RESPONSE TO COMMENTS

APPLIANCE EFFICIENCY RULEMAKING
FOR
COMPUTERS, COMPUTER MONITORS, AND SIGNAGE DISPLAYS

DOCKET #16-AAER-02

Comments on 45-Day Language

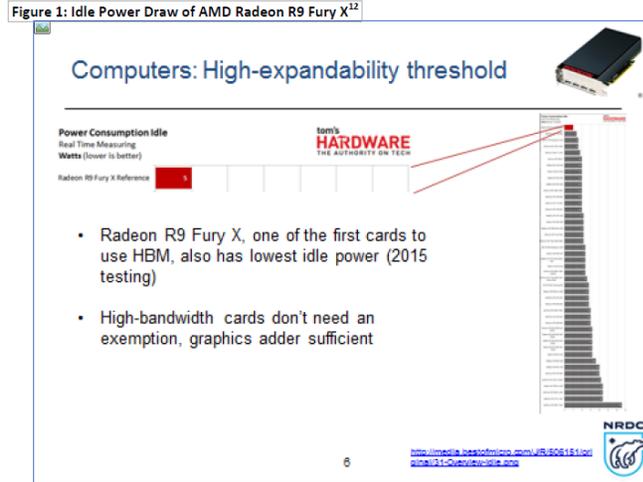
5c	NRDC TN#214153	<p>NRDC and Aggios also performed a comparative tear-down of two All-in-One computers, and found that one of these computers used half the energy of the other in short idle mode, and a third in long-idle mode, demonstrating the feasibility of achieving CEC’s tier 2 standards with 2014 technology.</p>	<p>While improving the efficiency of one particular system to comply with standards might be feasible today, it cannot be generalized for all computers especially for those with advanced functions and features. Standards and their time line for compliance are developed in a way that all computers comply by their effective date and no</p>

function or utility is eliminated to comply.
5d	NRDC TN#214153	Some machines are exempted or given a large allowance because they have premium or emerging features. While these features may be rare in today's market, and the initial implementation often draws a little extra power, they could be commonplace, or even ubiquitous, four years from now when the second stage of the standard goes into effect, and no longer require any extra power.	While staff agrees with such a trend in technology improvements in general, the trend cannot be projected precisely for several years from today. Staff has proposed standards that are flexible enough to allow for continued innovation and growth while stringent enough to ensure that manufacturers prioritize energy efficiency in their products. However, our regulations may not have completely predicted the future market. Therefore, the Energy Commission will be monitoring the market for shifts in technologies or features that were not expected at the time of the rulemaking and that could impact the energy savings expected from this rulemaking. If there is a shift toward one of these products or features, staff will consider proposing changes to the standards that will prevent these market changes from significantly reducing the overall energy savings projected in this rulemaking.

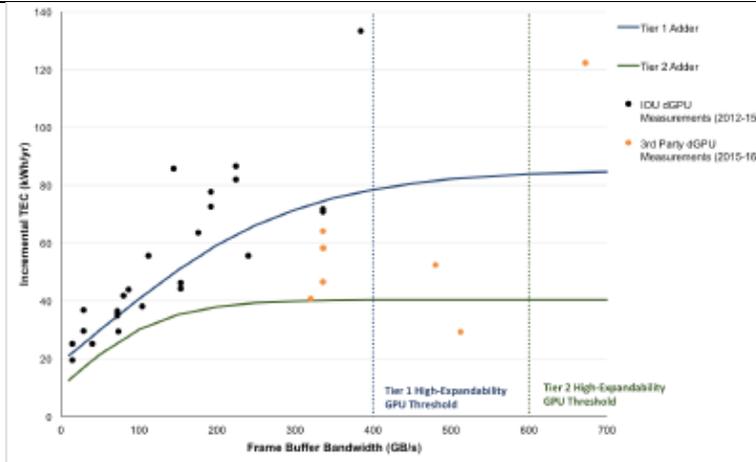
<p>computer monitors, but nothing for signage displays which require significantly more power for touch because of their much larger size. For consistency, if there is an On touch allowance for computer monitors, there should be one for signage displays. That said, the basic On power mode is achievable without the allowance.</p>	<p>change was made in response to this comment.</p>
6d	SMART, TN # 214160	<p>Third, IFPs may be networked and may have wake-on-touch or wake-on-proximity technology. ENERGY STAR for Displays 7.0 recognizes the differences between televisions, monitors and signage displays and provides the following adders for Sleep (Standby) mode: By contrast, the current draft allows 3.0W in Standby-passive mode.</p> <p>The first large (>61”) interactive flat panel signage displays to be certified under ENERGY STAR for Displays 7.0 are SMART Technologies’, so we deeply understand what is required to achieve certification. In our experience, 3.0W is very generous—perhaps overly generous—for a display without the listed adders, although achievable with both wake on touch and wake on proximity. An IFP with all three adders would be allowed 5.3W under ENERGY STAR, which only the top ~20% of products are expected to win. It is difficult to see how every IFP can be expected to draw at 57% of this best-in-class power in Standby.</p> <p>To properly reflect functionality, the base Standby-passive allowance should be reduced (perhaps to 1W) and adders for the functionalities listed above should be incorporated.</p> <p>The NRDC has made some good observations about stacking adders for monitors, but those comments</p>	<p>This comment suggests a change to the standard for televisions, which are outside the scope of this rulemaking. Therefore, no change was made in response to this comment.</p>

<p>don't apply to the above table—each functionality really does require the power listed above.</p> <p>SMART appreciates this opportunity to provide feedback. We hope that our practical experience with certifying the first large interactive flat panels under ENERGY STAR will help CEC adopt standards that are both stringent and achievable.</p>	
7a	Christopher Price on behalf of Console Enterprises TN#214157	<ul style="list-style-type: none"> • The Small Volume Manufacturer exemption's device cap is arbitrary, and prohibitively low. With a 40 device cap, the very startup model that built Silicon Valley in California, will have a major compliance and remediation incentive to leave the state. • A per-device cap also can impact new device types that may be subject to this rule, but are relatively inexpensive such as devices branded as "PCs" that have been sold for as little as \$9 publicly. • The small PC retailers that build their own machines, will now have to possibly retest each and every custom-built machine sold over their 40th unit cap. These rules would be imposed on a very small business selling as few as four PCs per month, possibly even less. • While ITI has noted the testing cost is approximately \$600 per product, this is not a comprehensive cost estimate in our view. It first does not include the real-world costs to initiate testing, both in-house and to source, and contract with a testing firm. Further, it also fails to take into account remediation costs if a small business is already manufacturing a device, or has to change 	<ul style="list-style-type: none"> • The cap on the number of computers of the same basic model that qualify for specific exemptions for small volume manufacturers is based on a calculation that balances an average cost of compliance test with the energy cost savings. In order to avoid significant impacts to small businesses, the following changes have been made: <ul style="list-style-type: none"> – The cap on the number of basic models is increased from 40 to 50. – The cap is removed for small-scale servers and notebooks. • No specific model is provided and staff was not able to find \$9 personal computers in the market to verify whether they are in the scope of the standards. • Small volume manufacturers are required to test the computers and fully comply if they build more than 50 units of the same "basic model". That means desktop and workstation
